# Office of the State Court Administrator

Archuleta County Officials  
Chairman of the Board – Clifford Lucero  
District 1 – Commissioner Steve Wadley  
District 3 – Commissioner Michael Whiting  
County Administrator – Bentley Henderson  
449 San Juan St.  
P.O. Box 1507  
Pagosa Springs, CO 81147

Dear Archuleta County Commissioners

As stated to you in our letter of March 2014, significant concerns regarding the health and safety of the Archuleta County Courthouse have been raised. Since receiving the complaints, we have completed a series of tests to determine if the safety of staff and the community are at risk. This letter serves to:

FCU serving the Probation Office

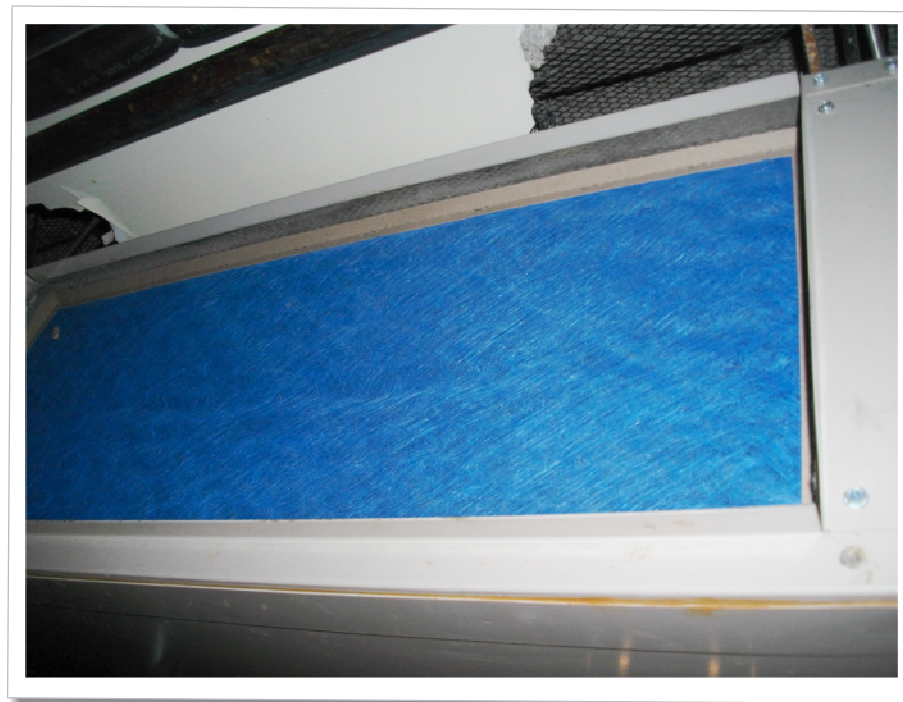
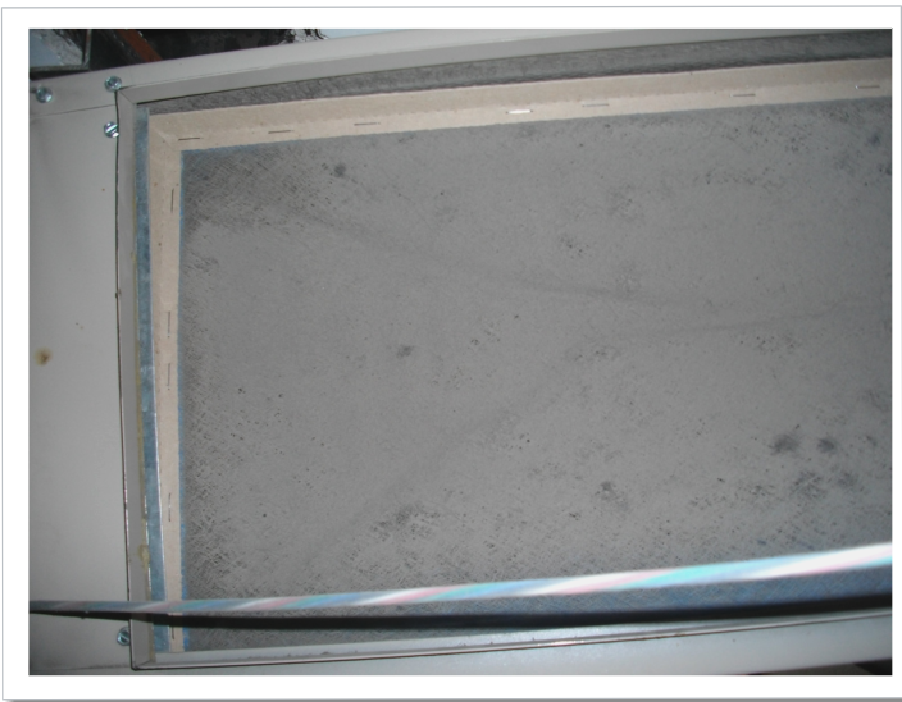
- 2. Repair all AC condensing units and heating coils.**
- 3. Provide outside make-up air to all FCUs.**
- 4. Increase the frequency of housekeeping in all occupied areas.**
- 5. Direct all bathroom exhaust systems to the outside.**
6. Have the roof framing system evaluated by a structural engineer during the roof replacement project (COMPLETED BY JAMES VAN LIERE IN OCTOBER 2014).
